RE: Administrative Amendment to Site Plan for Subdivision for 730 Coors NW  
Project Number 2019-002499 / Case Number SI-2020-00371

## 730 COORS NW

### SITE PLAN FOR SUBDIVISION

Sheet 1 of 3

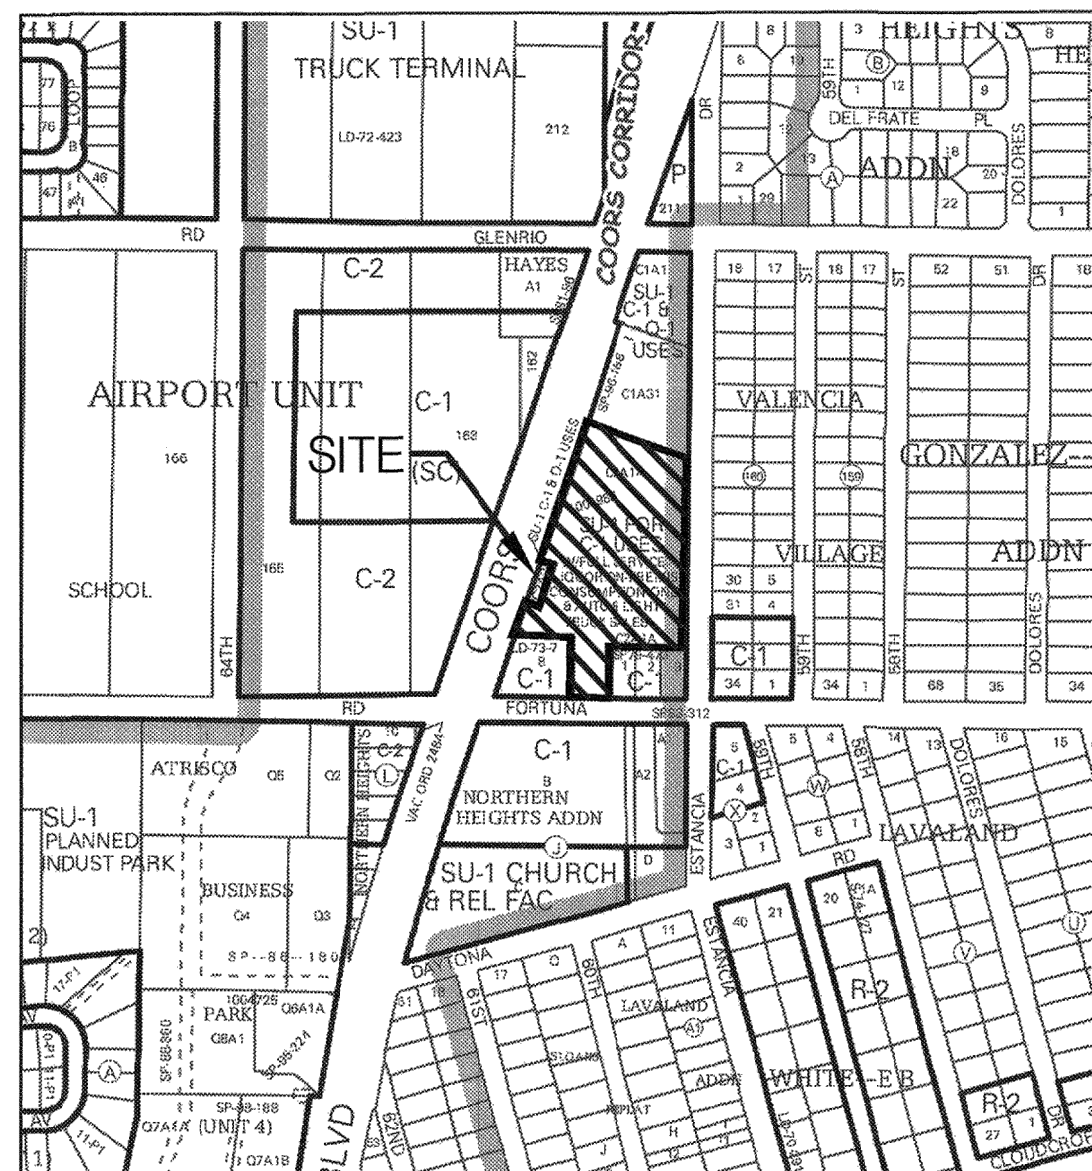
1 Administrative Amendment (06/24/2020): Provide vehicular access to and from Tract B through Tract C-2-A-1-A-2 and the existing driveway at Coors Boulevard. All or a portion of the existing building on Tract C-2-A-1-A-2 in the drive path will be demolished.
